UNITED STATES PATENT AND TRADEMARK OFFICE

Office Action Summary

10/055,582

DETAILED ACTION***Drawings***

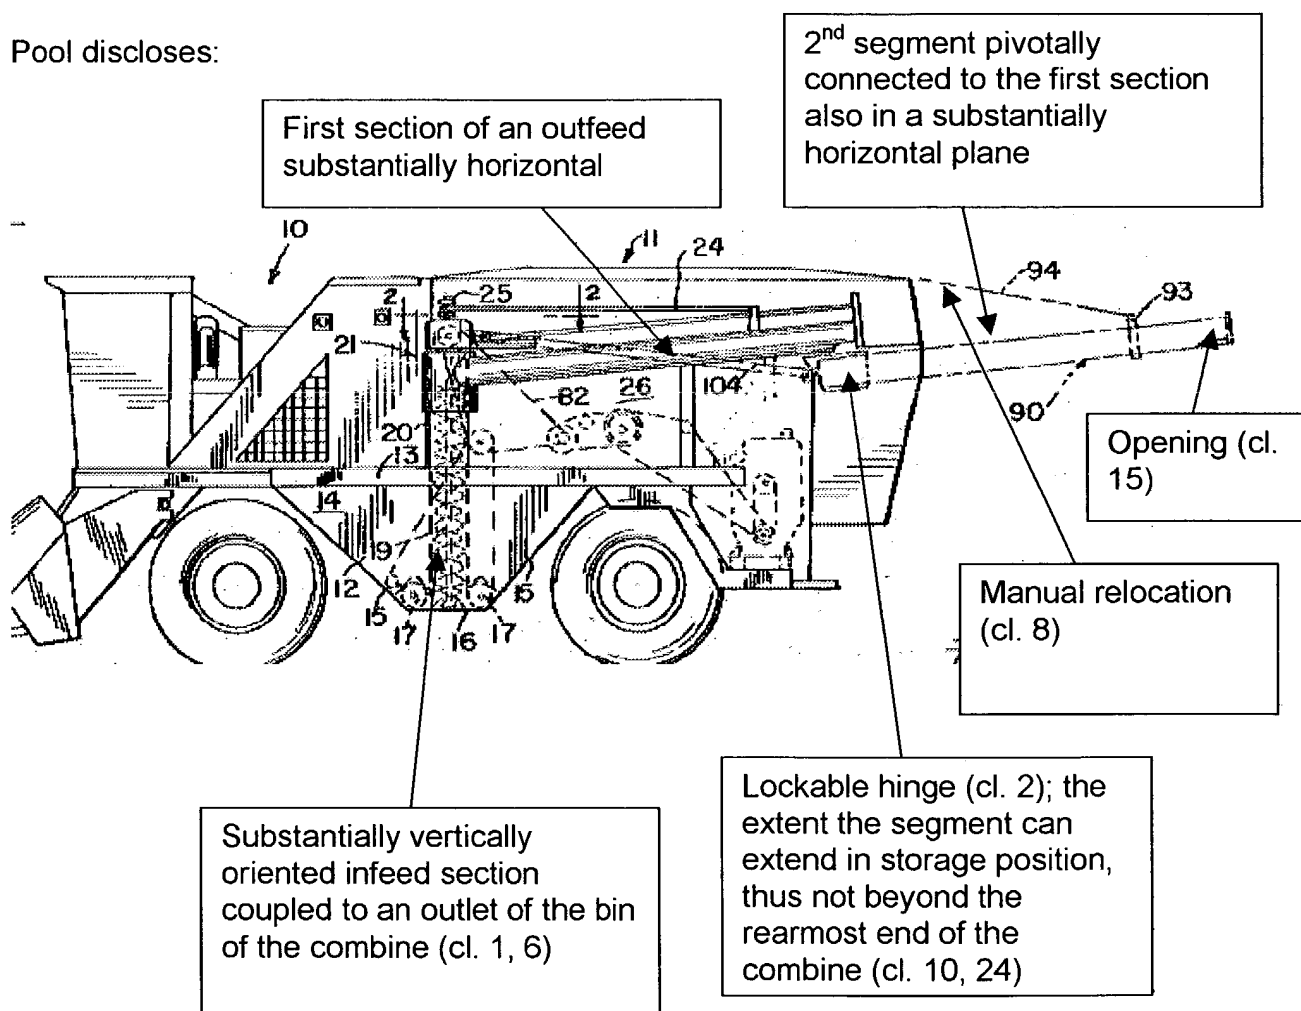
1. The drawings are objected to under 37 CFR 1.83(a). The drawings must show every feature of the invention specified in the claims. Therefore, the "actuator" (cl. 1, 6), "hydraulic cylinder" (cl. 22, 25, 28) must be shown or the feature(s) canceled from the claim(s). No new matter should be entered.

It is noted that in the original disclosure and in the drawings a hydraulic actuator was not shown. It is further noted that the concept of using a hydraulic actuator to move

to pieces relative to each other is well known. However, the Applicant has not shown in the drawings and in the disclosure how a newly proposed actuator would be novel in view of the state of art. Reviewing the disclosure, it is clear that Applicant's invention pertains to the auger sections. It is nowhere found that a hydraulic actuator would be novel to use and would solve any certain problems or would improve on the state of the art device.

Accordingly, the hydraulic actuator appears to be, subsequent to an Examiner's objection, an after thought addition to the drawings in order to overcome either the objection's to the drawings or an attempt to differentiate from those augers which do not use or require a hydraulic actuator.

Finally, the operation of the actuator by stating that "can be remotely actuated" (it is noted that "via remote operator" was a new matter addition to the disclosure) is not sufficiently disclosing how it actually works.

Therefore, the rejection is based on the original concept the Applicant believes is an improvement, which directly deals with the foldable auger sections.

Corrected drawing sheets are required in reply to the Office action to avoid abandonment of the application. Any amended replacement drawing sheet should include all of the figures appearing on the immediate prior version of the sheet, even if only one figure is being amended. The figure or figure number of an amended drawing should not be labeled as "amended." If a drawing figure is to be canceled, the appropriate figure must be removed from the replacement sheet, and where necessary, the remaining figures must be renumbered and appropriate changes made to the brief description of the several views of the drawings for consistency. Additional replacement sheets may be necessary to show the renumbering of the remaining figures. The replacement sheet(s) should be labeled "Replacement Sheet" in the page header (as per 37 CFR 1.84(c)) so as not to obstruct any portion of the drawing figures. If the changes are not accepted by the examiner, the applicant will be notified and informed of any required corrective action in the next Office action. The objection to the drawings will not be held in abeyance.

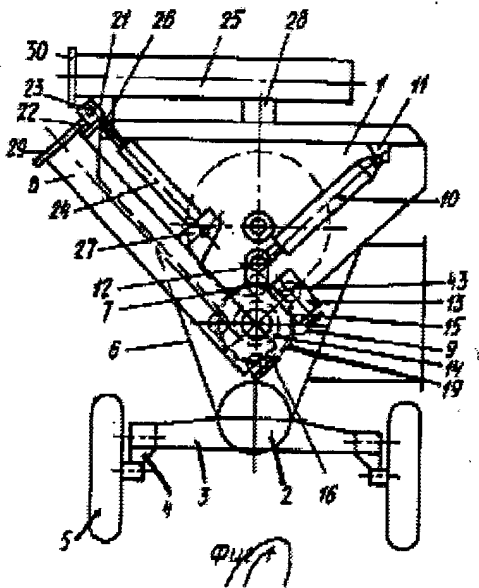
In re claims 4, 17-18, in storage position the flyers do not operate thus it is prevented to accidentally release through the open end any grain;

In re claims 5, 13, 23, 26-27, 31, in storage position both segments are parallel to the longitudinal axis of the combine;

Pool does not disclose a coaxial pivoted hinge connection between the first & the second segments.

Barinov as shown below and disclosed in the abstract hingedly & pivotally connecting a second segment for giving wider range of use of the discharge auger system.
